**Submission on Proposed Plan Change 7 – Rotokauri North Private Plan Change**

# Proposed Plan Change 7 Submission

Figure 15 -7a

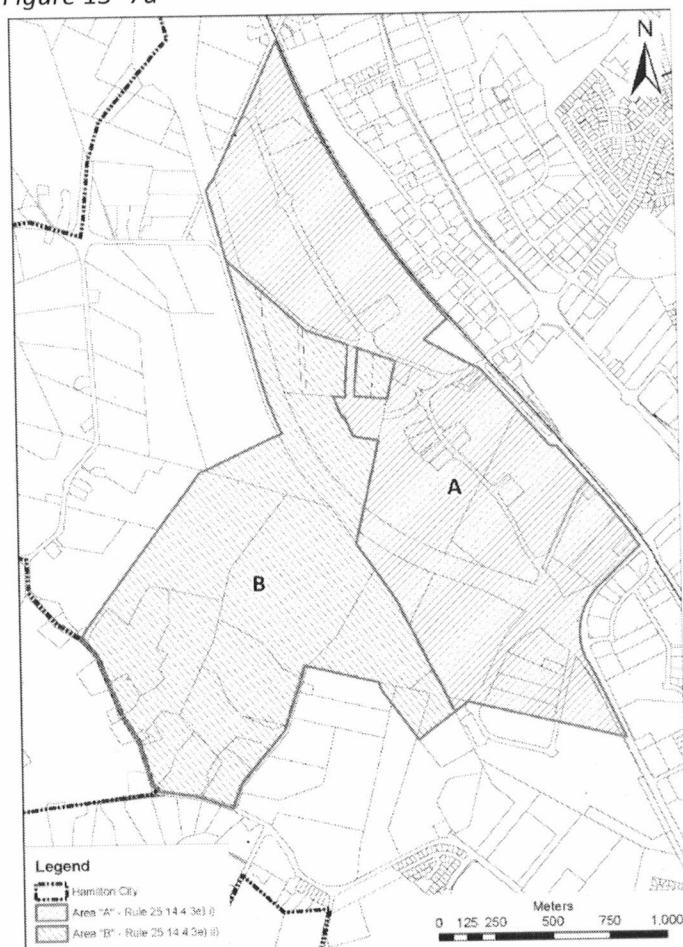
The proposed plan change is inconsistent with structure plan component *“3.6.3.2 Roothing”* in its entirety. The proposed area is within the stage 2 area, outside of Areas A and B (see Figure 15-7a). The Rotokauri Structure Plan indicates that the release of land beyond stage 1A (such as the PPC): *“will be contingent upon the availability of network capacity which may arise as a result of traffic generation”* and 3.6.2.3 d and e) provide that:

*Proposals for the development of land in ‘Area B’ on Figure 15-7a will require careful scrutiny to ensure that adequate network capacity exists to support the development, or will be provided as part of the development and they will not compromise the development of land in ‘Area A’ on Figure 15-7a. Development will require:*

e) The development of land outside Areas 'A' and 'B' (Figure 15-7a) will need to coincide with the northwards extension of Rotokauri Minor Arterial Road to connect with Te Kowhai Road at the City Boundary.

The PPC is clearly contrary to these provisions, and the developer is trying to dodge the full cost of developing ahead of the planned sequencing by exempting itself from these Rotokauri Structure Plan provisions. The PPC does not provide adequate transport network capacity outside of the PPC area to support the proposed development. The proposal does not achieve a sustainable expansion of the city and does not represent coherent and integrated development, because the transportation effects beyond the Rotokauri North boundaries have not been resolved.

- Either decline the private plan change; or
- Decline proposed inclusion of section 3.6 d (exemption of PPC area from Rotokauri Structure Plan), but approve the development subject to requiring the developer to adhere to all existing Rotokauri structure Plan provisions, including:
  - a) requiring they construct the Rotokauri Minor Arterial Road;
  - b) provide an ITA that adequately assesses impacts on the wider transport network and have that ITA peer reviewed.
  - c) cater for the demand generated within the wider transport network;

- d) requiring the developer to fund all necessary road network upgrades and additions.
- e) provide a full economic assessment of the financial impact on the remainder of the Rotokauri Structure plan area and including the likely cost of the required roading upgrades.
